HEARINGS – REQUEST TO ADDRESS COUNCIL

3. Planning and Land Use Committee – April 03, 2014

Date: March 20, 2014 **From:** Mike Wilson, Senior Planner – Urban Design
Subject: **Rezoning Application #00381 and Development Permit Application #000351 for 1002-1008 and 1012 Pandora Avenue** - Application to increase density and construct a four to six-storey mixed-use building

1 REVISIONS TO NORTH ELEVATION - MASON STREET

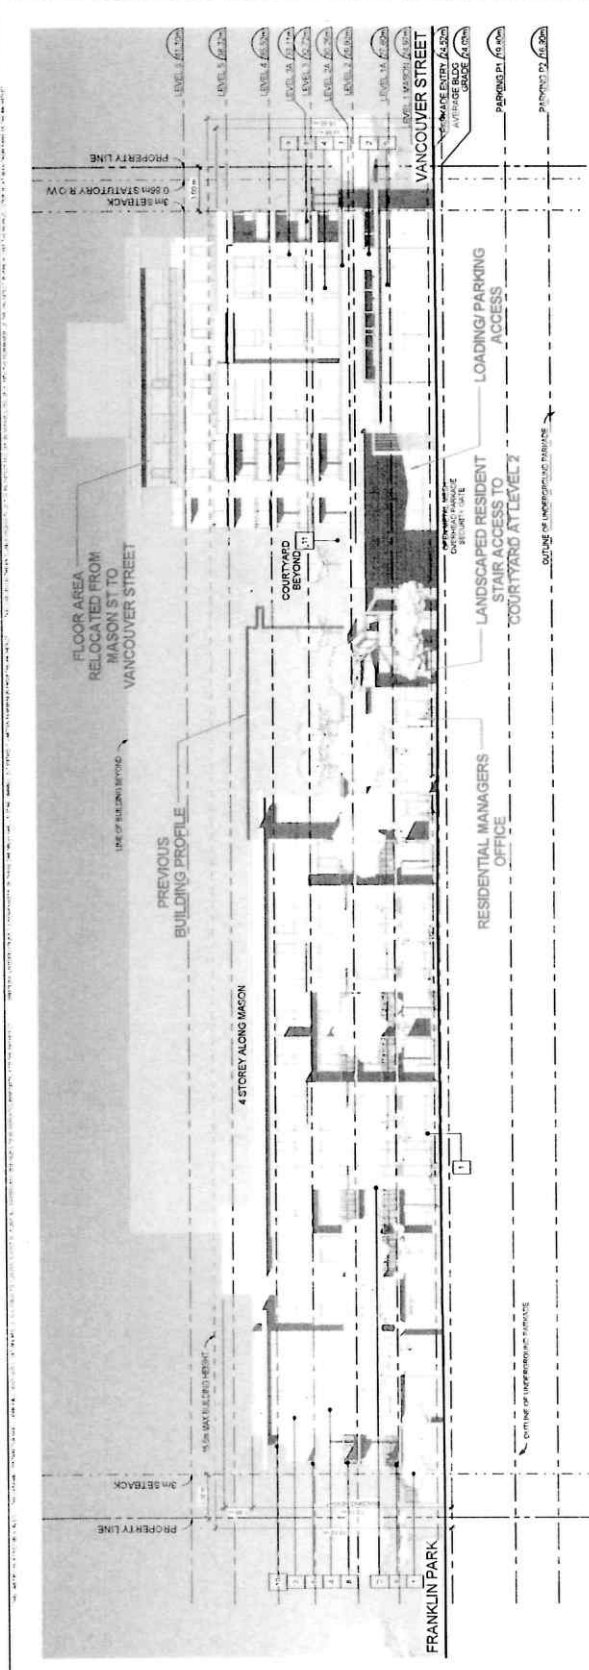
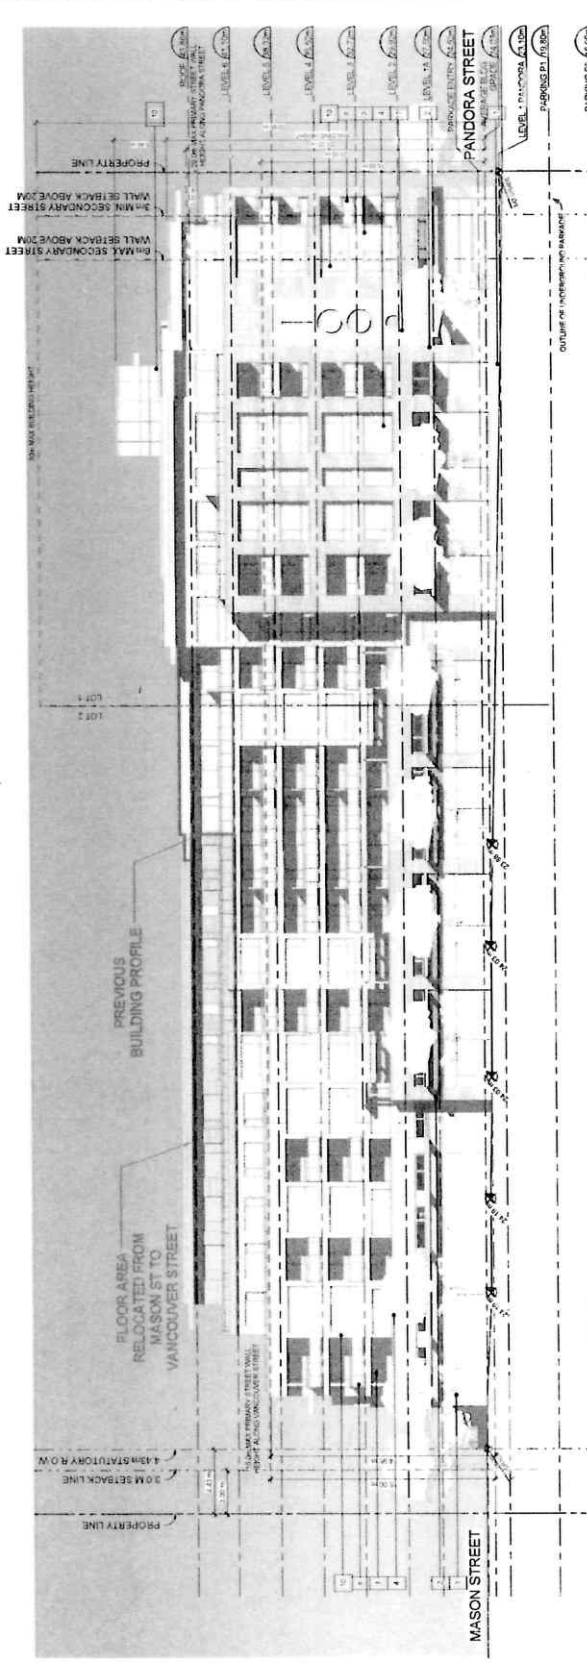
2. **Mark Kopinya, Blue Sky Properties, 1002-1012 Pandora Avenue:** He attended Planning and Land Use Committee last week and would like to provide a further update and clarification on the proposal. They are already looking at moving two floors from Mason Street to Vancouver Street to address massing; they would restrict hours for delivery trucks; they are working with Engineering about proposed traffic calming at Mason and Cook Streets; they are working with Engineering on bike lanes and will accept their suggestions. They have presented these to the North Park Neighbourhood Association as well as a letter to the City. Two additional items mentioned at the meeting were windows on the mid-block walkway and not enough at grade bike racks; both can be done and they will look at both. They can commit to LEED silver equivalent. It is their intention to own the property as rental housing and are prepared to secure the rental for ten years and using the precedent already set at the City of offering the strata units to tenants. They have always been clear that their target tenant will be a grocery store; the Vancouver Street stores will be boutique retail stores.
